**East Midlands Gateway
Phase 2 (EMG2)**

Road Safety Audit 1

SEGRO
East Midlands Gateway 2,
Leicestershire
Stage 1 Road Safety Audit (Entire Scheme)

Document Number	EMG2-BWB-GEN-RSA-RP-TR-0001_RSA1
BWB Reference	220500
Prepared By:	BWB Consulting Ltd
On Behalf Of:	Leicestershire County Council/National Highways

FIGURE 2 – Location of problems identified in this audit (M1 Northbound, Junction 24 and Proposed A50WB Link)

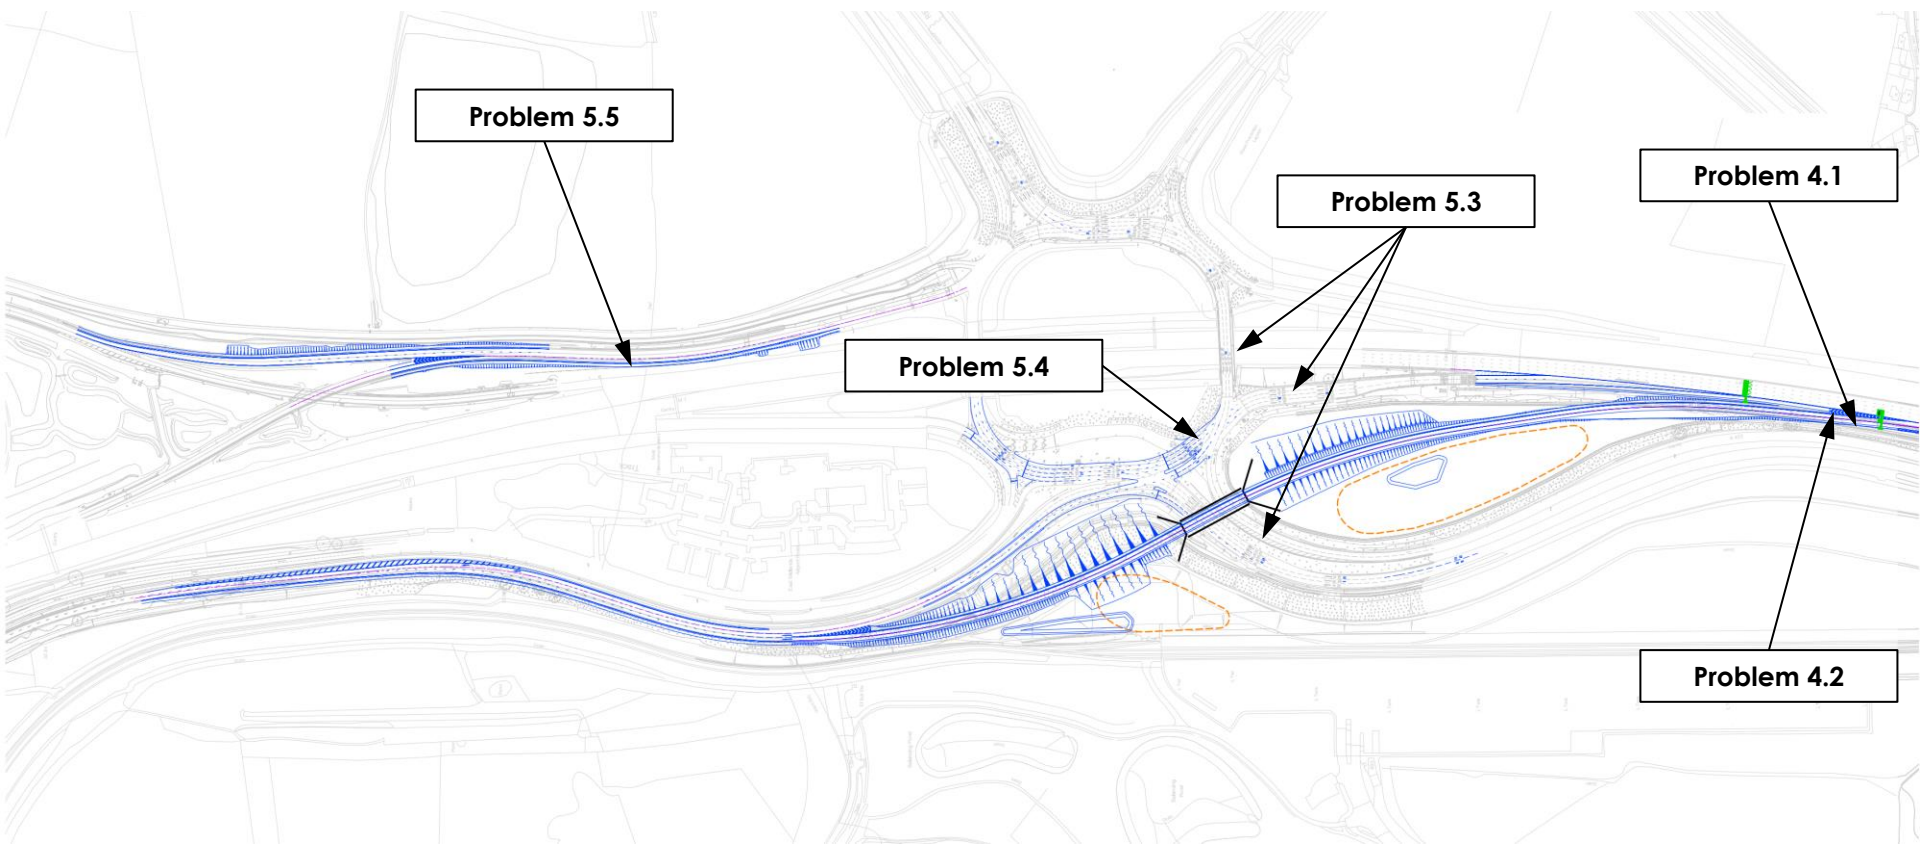
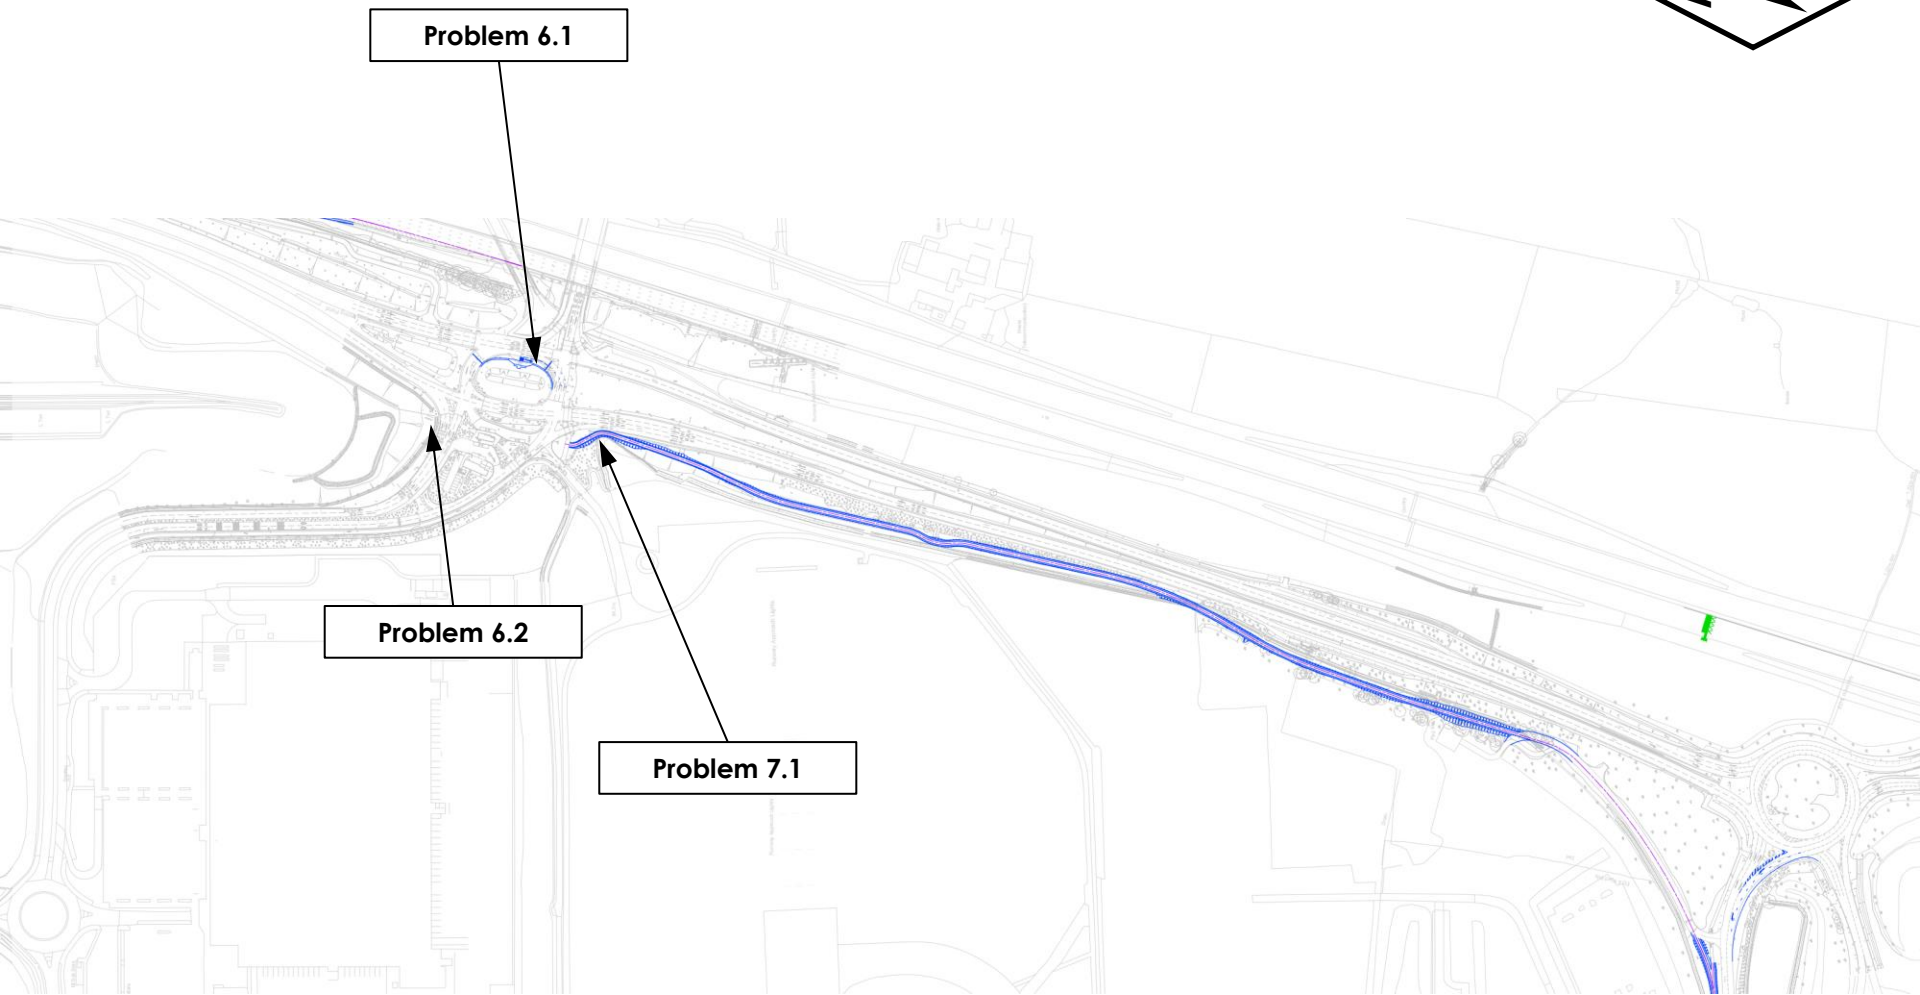
4.1 Location: M1 Northbound approach to new A50 link.

Summary: Potential for side swipe or shunt type collisions on the M1 Northbound as result of impeded forward visibility.

Drivers travelling north on the M1 will be provided with a new exit slip straight after the overbridges on at the A6/Old Ashby Road. The forward visibility to the slip road has not been shown on the design drawings. Because of the bridge abutments within the nearside of the northbound M1, drivers may not be able to see the approaching slip road and visibility to any stopped or queuing traffic may also be obstructed. This could lead to sudden lane changes, braking, or swerving at the new A50 diverge. This could lead to shunt or side swipe collisions on the M1 northbound after the overbridges. It should be noted that this problem is also raised within the departures from standard.

4.2 Location: M1 Northbound approach to new A50 link.

Summary: Potential for side swipe or shunt type collisions on the M1 Northbound as a result of proximity of two diverges.

The new exit onto the A50 link is provided very close to the exit for Junction 24. This could cause confusion for motorists who want to exit at Junction 24 resulting in them attempting to take the wrong exit, leading to shunt or side swipe collisions as they brake suddenly or make last second lane changes. It should be noted that this problem is also raised within the departures from standard.

5.3 Location: Junction 24 circulatory, A453 (W) approach and M1 Northbound off slip.

Summary: Potential for shunt type or side swipe collisions around the junction due to misleading carriageway markings.

As a result of the amendments at Junction 24, there are a number of changes to the road markings to update the lane destination markings on the approaches to the

junction on the M1 northbound off slip, the A453 approach from the airport and the southern and western side of the circulatory carriageway. However, some of these markings are not consistent with each other and could lead to drivers getting confused and braking sharply or changing lanes at the last minute resulting in shunt or side swipe collisions.

5.4 Location: Western side of the circulatory carriageway at Junction 24.

Summary: Potential for shunt type or side swipe collisions due to widening and short merge lengths.

It is proposed that the circulatory carriageway will be amended to provide two additional lanes, which results in there being six lanes at the stopline at the western side of the circulatory carriageway. There are three lanes provided from the M1 overbridge that feed into these lanes. However, the inside lane provided at the overbridge feeds into five of the proposed six lanes. As a result of this, anyone in the inside lane would have a lot to consider as they circulate the junction and attempt to get into the correct lane in a relatively short distance. This could result in shunt type collisions and collisions associated with sudden lane changes.

5.5 Location: A50 eastbound/M1 southbound link to Junction 24.

Summary: Potential for side swipe collisions on the approach to Junction 24 due to short merge distance.

Vehicles travelling eastbound on the A50 and heading towards Junction 24 currently do so in a single lane, which flares to two lanes where it joins the M1 southbound diverge slip before flaring to three lanes on the approach to Junction 24. As part of the proposals

the single lane link from the A50 will flare to two lanes prior to the M1 southbound diverge slip and then become three lanes where the diverge slip joins it. This means that vehicles exiting the M1 southbound will be guided into lane 3 at the approach to Junction 24. Whilst it is understood that vehicles would be able to access the A453 towards Nottingham from the middle lane, the East Midlands Parkway station is only signed from the inside lane. This could result in drivers thinking they need to change from lane 3 to lane 1 over a short distance on the approach to the Junction 24, potentially resulting in them undertaking last minute lane changes, or panicked manoeuvres, leading to side swipe collisions.

The signage and road markings on the M1 northbound need to be very clear to enable motorists to understand which lane they need to be in and where they will be exiting as they may not be able to see the approaching junction.

The signage and road markings on the M1 northbound need to be very clear to enable motorists to understand which lane they need to be in and where they will be exiting. Junctions 24 and Junction 24A need to be clearly marked and signposted to reduce the risk of sudden lane changes.

The lane destination markings throughout the junction and on the approach arms should be reviewed to ensure that they are all correct and guide drivers properly through the junction and mirror information provided on upright signing.

The lane destination markings and signage in advance of the proposed widening on the western side of the circulatory, needs to be very clear to drivers as they circulate the junction to ensure that they are in the correct lane. If possible, the lanes around the southern side of the roundabout and M1 overbridge should be rationalised to provide a more even split of traffic flow as they flare around the western side of the roundabout. This could be done by making the middle lane on the M1 overbridge flare into the two A50 lanes for example, but it is understood that there may be capacity reasons behind the current proposal and lane allocation. Likewise, gantries could be provided with lane allocation signage to make it clearer to drivers which lane they should be in, assuming that these would not obstruct the overhead signal heads.

Ensure the signage provided on the A50 eastbound/M1 southbound link is clear and shows that the A453 and East Midlands Parkway station can be reached from lanes 1 & 2. It is unlikely that many vehicles would be accessing the M1(S) from this approach as they would have either just left the M1 southbound, or they would have taken the direct link from the A50(E) to the M1(S) so the need for this to be signed is not considered necessary and could just add to the confusion.

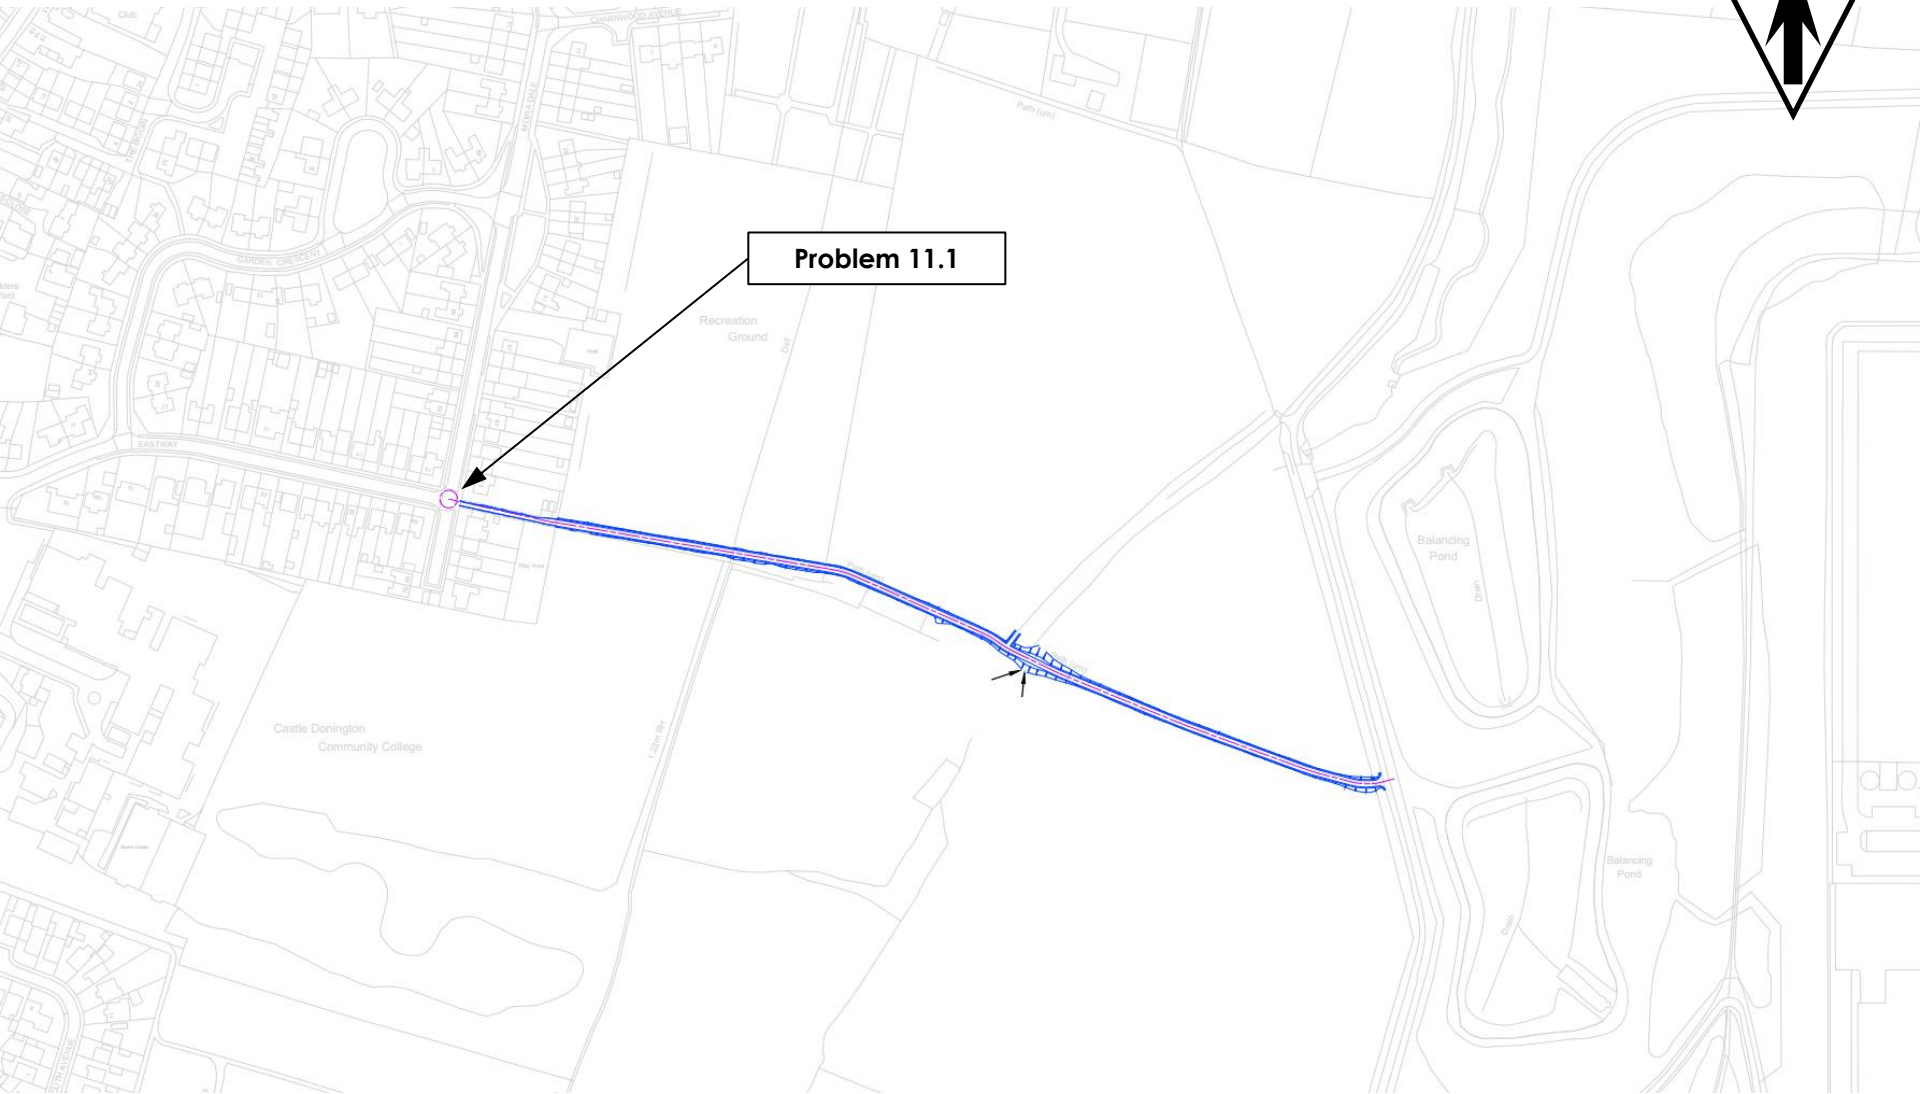
6.1 Location: Eastern side of the EMG1 access junction.

Summary: Potential for vehicles to collide with the kerb resulting in loss of control type collisions.

On the eastern side of the gyratory, at the A453 (N) the proposals include widening of the carriageway to provide two lanes for vehicles turning right into the EMG1 site. The movement from the A453 (N) into the widened section of carriageway seems like quite a tight manoeuvre to get into the new proposed lane with a short taper into the widened area. Whilst this is not an issue if vehicles are moving off from a standstill at the A453 (N) traffic signals, if vehicles were undertaking this manoeuvre at speed it could result in them clipping the kerb on the central reserve prior to the junction and losing control.

6.2 Location: Proposed pedestrian facility at EMG1 access junction.

Summary: Potential for pedestrians to be injured by VRS or errant vehicles.

The proposed footway link to the new crossing provided over the EMG1 access appears to be in close proximity to the existing VRS provided on the exit from the EMG1 site. This could result in pedestrians walking within the working width of the VRS. Which could result in pedestrians being injured by the VRS should it be struck. It is also unclear if the VRS obstructs the forward visibility to the crossing, which could lead to pedestrians being struck if they are not seen by approaching motorists.

7.1 Location: Proposed active travel link near EMG1 access.

Summary: Potential for users to collide at bend in facility.

The proposed active travel link along the A453, joins the existing facilities at the EMG1 access. Prior to the point where the proposed facility joins the existing facility, there is a bend proposed in the facility, which has a post and rail fence and vegetation provided on the inside of the bend. The forward visibility splay shown on the drawing appears to go through the fence and the vegetation, which could result in users not seeing one another and colliding as they navigate the corner.

11.1 Location: Moira Dale End of the upgraded link.

Summary: Potential for cyclists to be hit by vehicles or cyclists to hit peds due to restricted visibility.

As part of the proposals there is an existing PRow (footpath) that runs between Moira Dale at its western end, to Diseworth Lane at the eastern end which is to be upgraded to a cycle link. Site observations indicated that this is a well-used footpath. However, where the link exits onto Moira Dale, the facility emerges from between two dwellings, meaning there is a hedgerow one side and a close boarded fenceline the other, which could limit visibility for emerging cyclists. This problem is exacerbated by the fact that the facility joins Moira Dale opposite its junction with Eastway. This could mean that cyclists are not aware that they may be about to emerge onto the carriageway on Moira Dale, which could result in them being hit by vehicles, or colliding with pedestrians as a result.

The kerbed central island at the A453 northbound roundabout entry (offside) should be realigned to smooth out the movement for vehicles entering the new flared lane.

Ensure that the footway is not provided within the working width of the VRS barrier. The forward visibility splay should also be checked for vehicles exiting the site seeing pedestrians crossing the carriageway to ensure it is not obstructed by the VRS.

The forward visibility splay on the active travel link around the bend should be kept clear of obstructions to ensure users can see each other as they approach the bend.

Cyclists should be forced to slow down as they exit the cycle link onto Moira Drive. This could be done by providing a chicane with pedestrian guardrail to ensure a slower speed, or by providing adequate signage or markings to warn cyclists. The visibility for cyclists exiting the link onto the footway should also be checked to ensure that it is suitable and sufficient warning, markings or tactile paving provided for pedestrians should be provided if not.
